CASE SUMMARY SHEET

CASE NUMBER: V22-09-27

REQUEST: V22-09-27 – Justin Sullivan requests a variance to CLURO Section 8.1.1.4. Allowed Setback Encroachments, Sq. 42 Lot L, R-1X Single Family Residential-Existing Small Lots District, 2351 Villere St.

CASE SUMMARY SHEET**CASE NUMBER: V22-09-28****DATE RECEIVED: August 1, 2022****DATE OF MEETING: September 13, 2022 and September 27, 2022****Address: 320 Lamarque St****Subdivision: Old Town of Mandeville****Zoning District: R-1 Single Family Residential District****Property Owner: John Crane****REQUEST: V22-09-28 – John Crane requests a variance to CLURO Section 9.2.5.7 Live Oak Protection Requirements, Sq. 13 Lot 6, R-1 Single Family Residential District, 320 Lamarque****CASE SUMMARY:**

SITE PLANS for LOTS 320 & 324 LARMARQUE ST. SCHEME-4

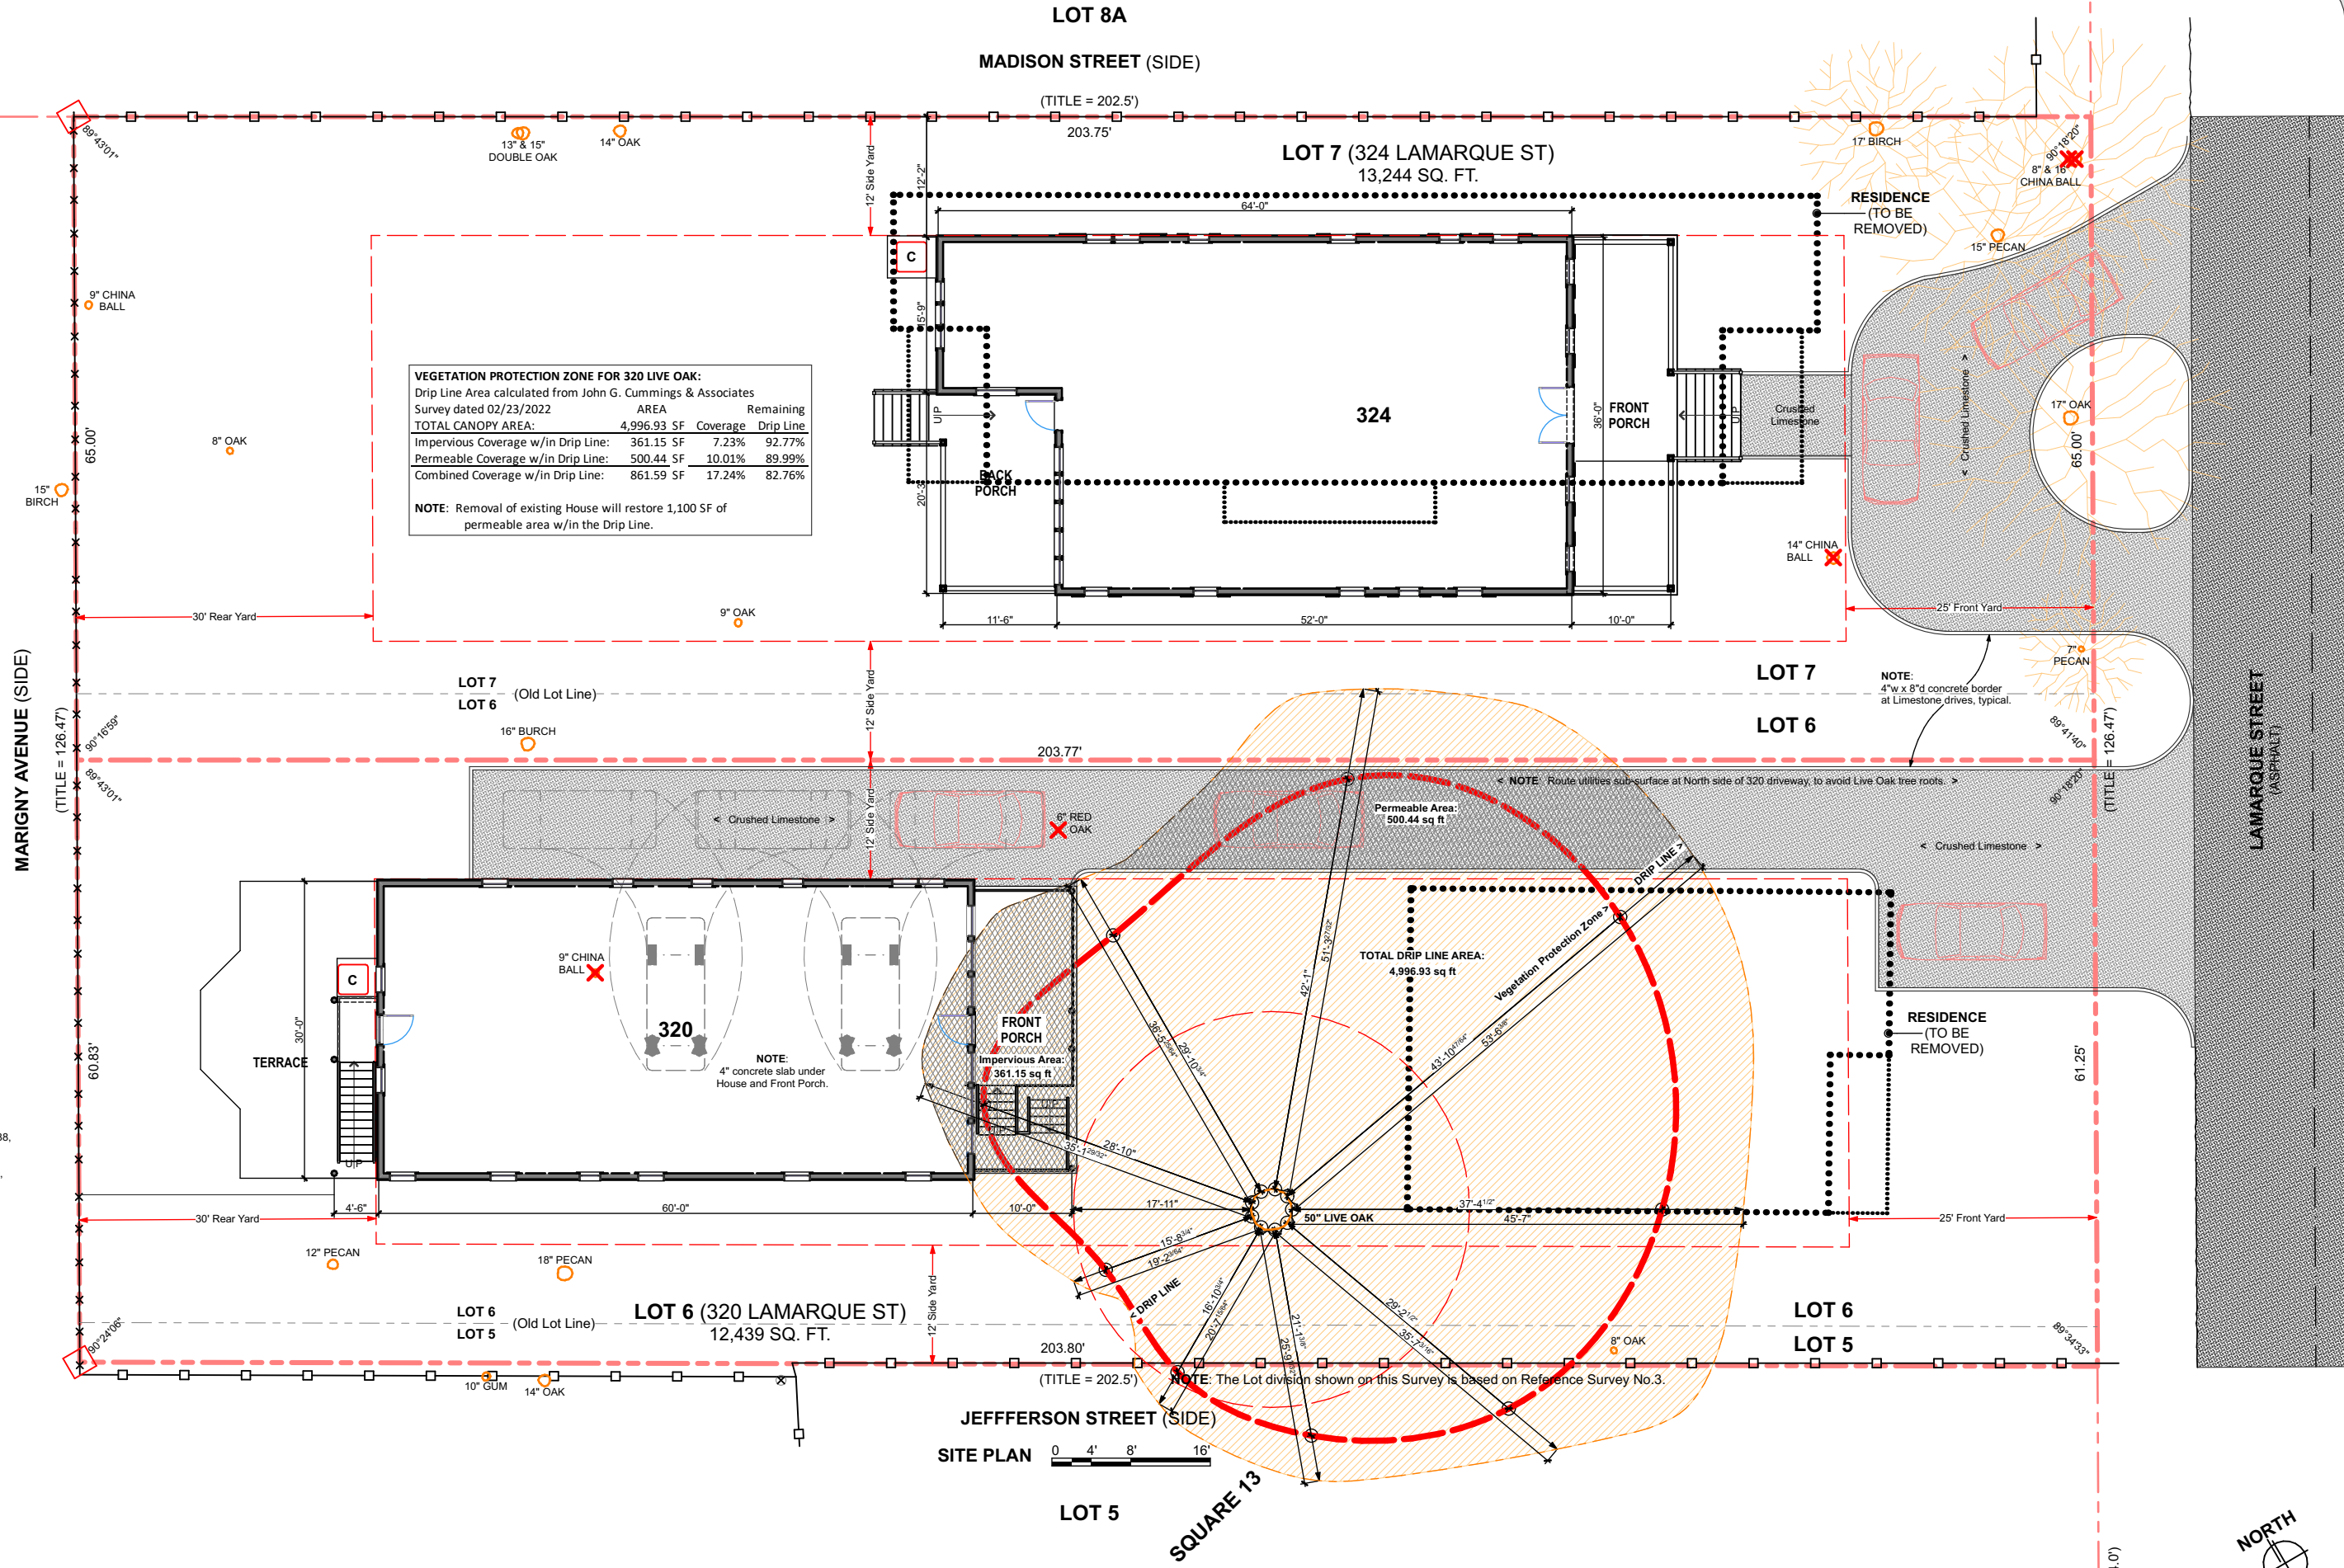
A submitted site plan by K & W, Project Number K2216 revised August 19, 2022 was reviewed for compliance with the live oak protection requirements. The plan shows an existing 50" *Quercus virginiana*, live oak, located in the buildable area along the southern side yard setback line. Based on the submitted plan the following areas of concern are:

1. The driveway along the north side of the property encroaching within the Vegetation Protection Zone (VPZ).
 - a. After reaching out to the property owner it was clarified that the driveway would be of crushed limestone with ground laid concrete curbing and no soil removal or soil compaction.
 - i. In addition to what the property owner is going to do the property owner should also use crushed limestone that is comprised of different sizes to prevent compaction of the limestone and the property owner can lay down a geotextile fabric to prevent the crushed limestone from migrating down into the soil.
 - b. The branches of the live oak tree over where the proposed driveway is to

be installed are low and would not easily allow construction access into the site without damaging the tree.

2. The front porch encroaching within the VPZ.
- a. The plans show a front porch encroaching into the western side of the live oak with a 4" concrete slab.

3. The existing structure on the site is noted to be removed and where ~50% of the structure is located within the VPZ.
 - a. The property owner is planning to have the structure removed by working from the front of the house toward the back with all machinery staying on top of the existing slab. Once the main structure is completely removed, the contractor will carefully remove the slab, working from the rear to the front. This will allow the structure to be removed while doing minimum harm to the existing live oak.

- i. Since the property owner is also developing the lot to the north all construction access should be done on this site to further protect the live oak and to also prevent the need for a construction access road.

- ii. If a construction access drive/road is preferred it should be installed before construction as described below:
 1. The road shall have an 8 - 12" thick layer of mulch on the maintenance road with wooden boards that are to be approved by the landscape inspector and a 5" thick layer inside tree protection area. This shall protect the soil from compaction, will still allow access unto the site, and will also allow the tree roots to breathe.

2. A maximum height clearance should be established based on the lowest limb to ensure that vehicles or equipment do not damage any of the limbs of the tree.

- i. If the front porch is approved to remain within the VPZ the 4" concrete slab should be removed, and pier type foundation should be utilized within the VPZ. The footing locations should be hand dug with a licensed arborist on site to approve the location of the

footings and to also verify that no roots are damaged during the time of construction. In addition, the property owner should have the areas outside of the VPZ root prune to protect the existing roots from additional damage when the slag is being dug.

- i. In addition to the removal of the structure and slab, the area where the slab was originally should be left as is until the area of the new slab is dug out and the excavated soil should be used to fill in the previously existing structures slab area. This will allow the site to keep existing native soils and allow the tree to eventually grow new roots in the area where the structure previously was.
